Access Compliance Report

Public Rights-of-Way

Intersection ID: 10034320	Main Street: PERIMETER_PY	Cross Street: N/A	Location: SW
ADA ID: 02FB3F40A6AE	Ramp Type: Perp	Initial Pass/Fail: Fail	Overall Compliance: No
Severity Score: 22.5			
Codes/Mitigation Info/Possible Solution		Field Measurements/Component Compliance

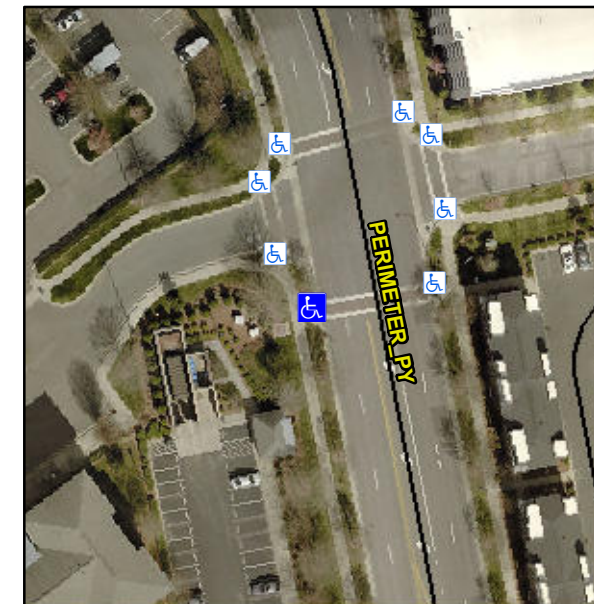
Not Found, R304.5.1, R304.2.2, R304.5.3

Compliance	Description	Data	Compliance	Description	Data
N/A	Ramp Length (in)	94.0	No	Ramp Slope (%)	10.3
No	Ramp Width (in)	46.5	No	Ramp XSlope (%)	2.3
N/A	Flare Type LT	N/A	N/A	Flare Type RT	N/A
N/A	Flare Slope LT (%)	N/A	N/A	Flare Slope RT (%)	N/A
N/A	Flare Traversable LT?	N/A	N/A	Flare Traversable RT?	N/A
N/A	Landing Length (in)	N/A	N/A	DWS Provided?	N/A
N/A	Landing Width (in)	N/A	N/A	DWS Contrast?	N/A
N/A	Landing Slope (%)	N/A	N/A	DWS Length (in)	N/A
N/A	Landing X Slope (%)	N/A	N/A	DWS Full Width?	N/A
N/A	Landing Curb? (Y/N)	N/A	N/A	DWS Offset (in)	N/A
N/A	Shared Landing?	N/A			
N/A	Gutter Ponding?	N/A	N/A	Gutter Slope (%)	N/A
N/A	Gutter Lip Ht (in)	N/A	N/A	Gutter X Slope (%)	N/A
N/A	Painted X Walk1?	Yes	N/A	Painted X Walk2?	N/A
	X Walk 1 Direction	To E		X Walk 2 Direction	N/A
N/A	X Walk 1 Width (in)	72.0	N/A	X Walk 2 Width (in)	N/A
	X Walk 1 Slope (%)	2.6		X Walk 2 Slope (%)	N/A
	X Walk 1 X Slope (%)	2.0		X Walk 2 X Slope (%)	N/A

Remove & Replace Entire Ramp.
